CMB Meeting Minutes #156

REFERENCE Project No. M544.1, Contract No. 149 Task 1-8.02

SUBJECT: Configuration Management Board Meeting # 156– Rev. No. 0

**MECHANICAL - FIRE PROTECTION
 FIRE PROTECTION PLAN
 FOURTH STREET PORTAL LAYOUT AND DETAILS**

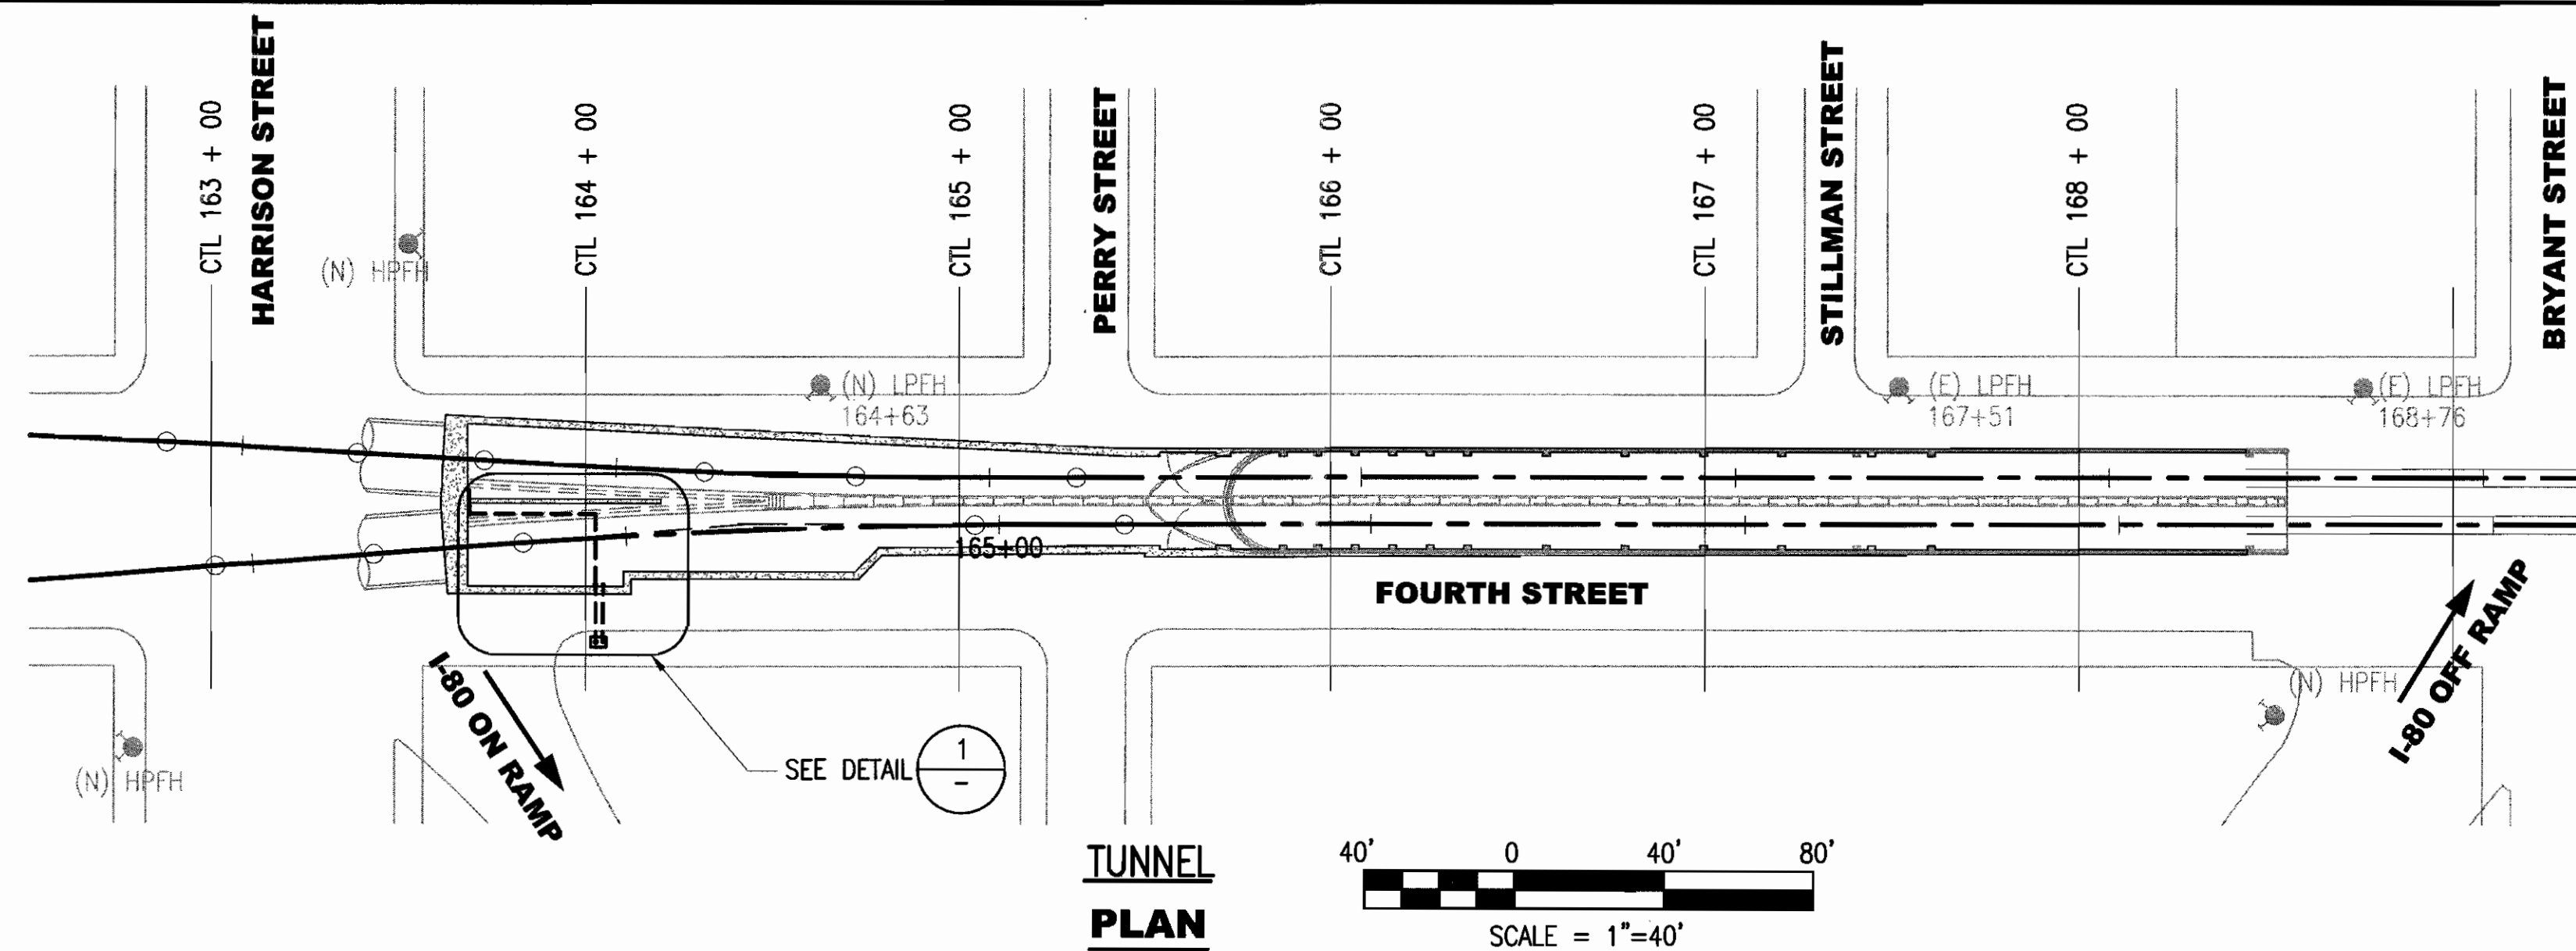
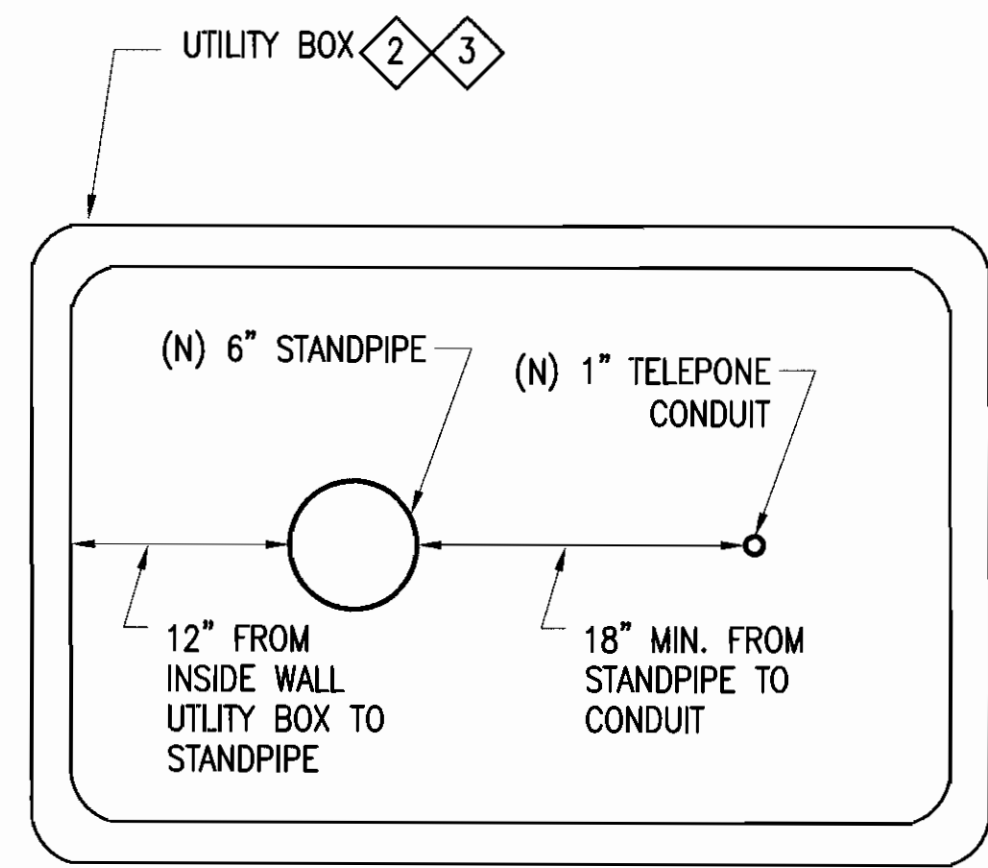
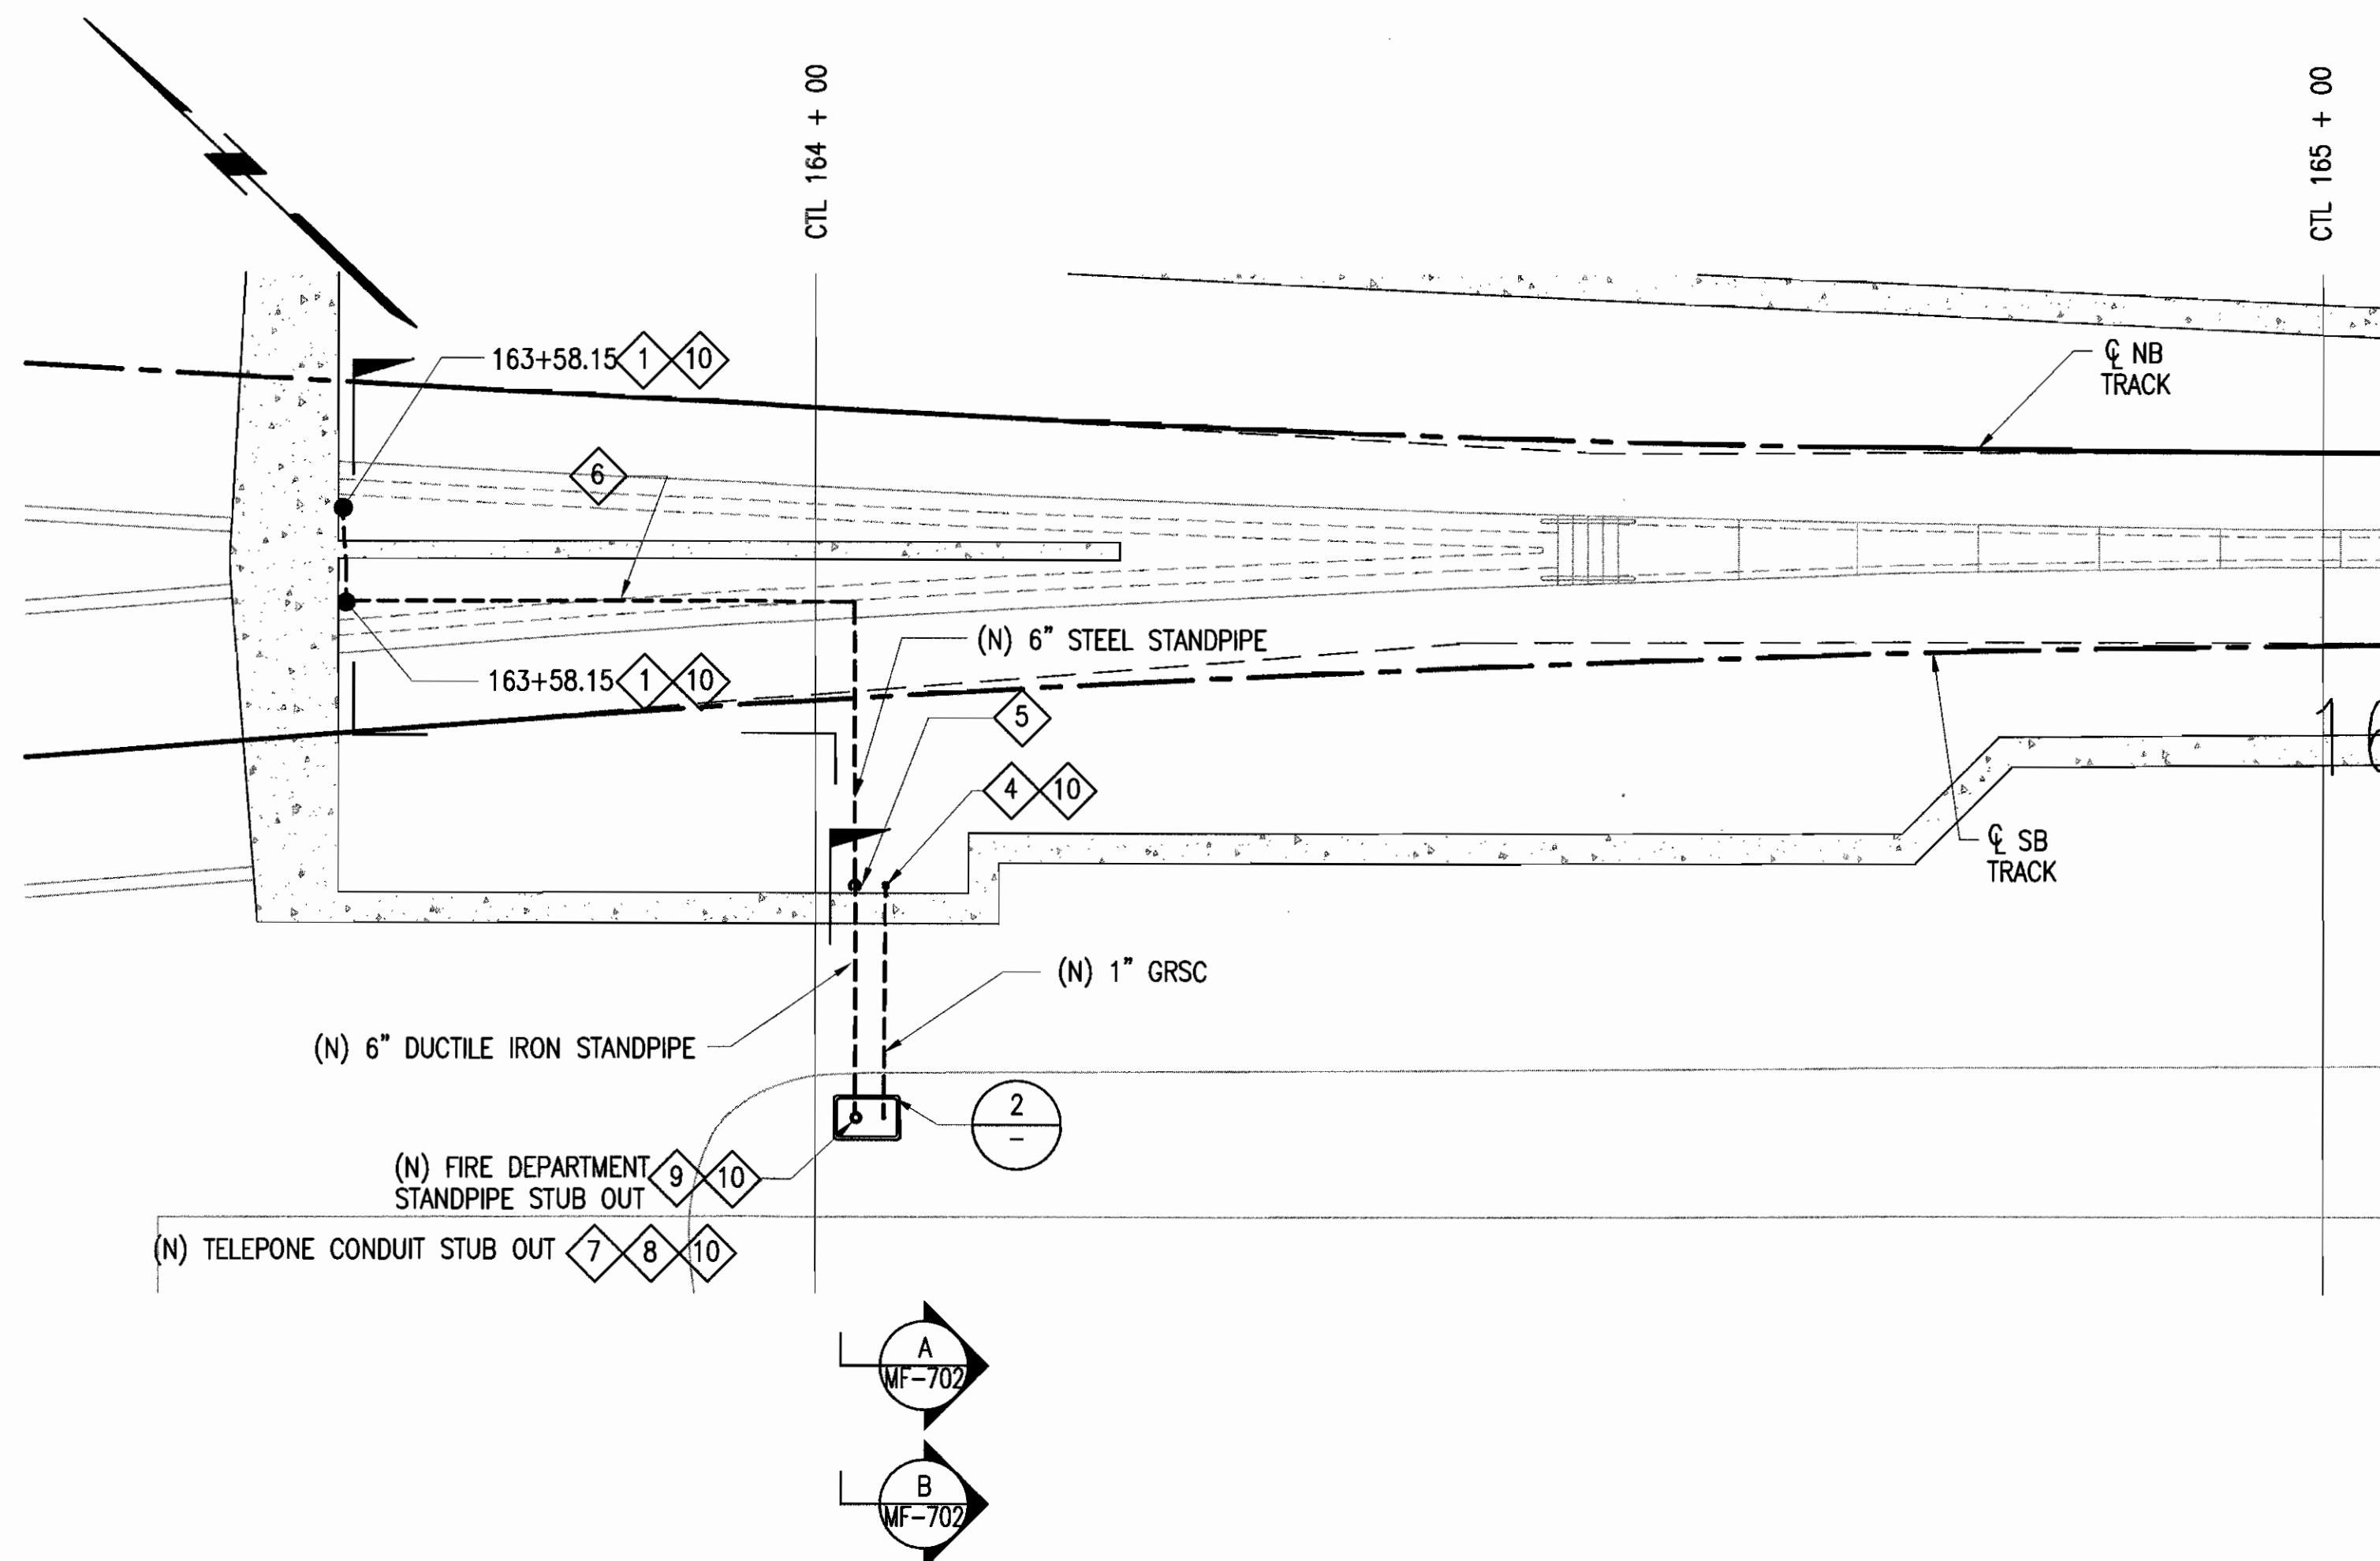
<p>Description of PCC: Inclusion of standpipe piping, telephone conduit, and casing at Fourth Street Portal. The piping, conduit, and casing will support equipment used by San Francisco Fire Department (SFFD) for firefighting activities in the tunnel. Portions of the piping and conduit will run inside their respective casing, which will be embedded in the structural portal wall and/or slab. The piping will be used for installation of surface mounted Fire Department Connection (FDC); and conduit will be used for the installation of surface mounted Fire Phone.</p> <ul style="list-style-type: none"> • Install approximately 30 lf of 1” galvanized rigid steel conduit for fire phone • Install approximately 30 lf of 6” ductile iron pipe for FDC • Install approximately 100 lf of 6” schedule 40, hot-dipped galvanized steel pipe for FDC • Install approximately 90 lf HDPE casing with casing insulators • Install utility box, bedding, and thrust block • Obtain all necessary permit(s) and submittals to DPI and SFFD, to install piping and conduit • Test pipe for leaks

<p>Reason/Need for PCC: SFFD requires an FDC and Fire Phone for tunnel standpipe system at the Fourth Street Portal.</p>
<p>Location/Station: From approximately station 164+08 (new utility box) to approximately station 163+58, (standpipe stub outs).</p>
<p>Configuration Control Analysis: Limited area where FDC piping and fire phone due to limited space at and near the portal.</p>
<p>Recommended Action:</p>
<p>Estimate:</p>
<p>Spec. Ref.:</p>
<p>Drawing Nos.: Dwgs MF-001, MF-501, MF-702</p>
<p>Attachments: Dwgs MF-001, MF-501, MF-702</p>
